SERVICE BULLETIN SB02.03

Machines/Models: XRT 27/33 **Serial Numbers:** 1000- 3153

PURPOSE: To simplify the operation and improve the safety of the Guardrail and Gate Locking Pin Assemblies.

Figure 4

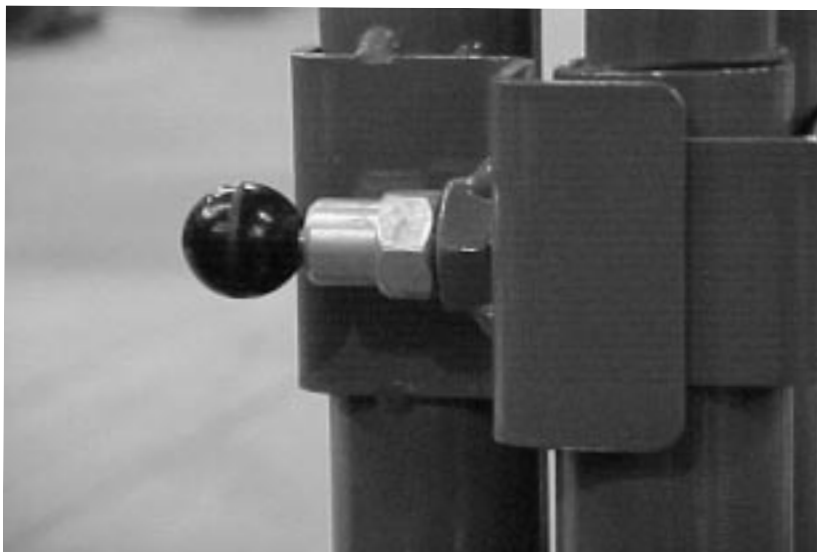
1. See figure 1, Remove and discard pin and lanyard assembly on right side of entry gate by drilling the rivet used to attach the lanyard to the guardrails. See figure 2
2. Install new pin assembly through the first hole in the guard rail then install the clip as per diagram (figure 3.)
3. Slide pin the rest of the way in place (figure 4.)
4. Repeat steps 1-3 on the left side of the entry gate using the other pin and clip.

New pin fully installed
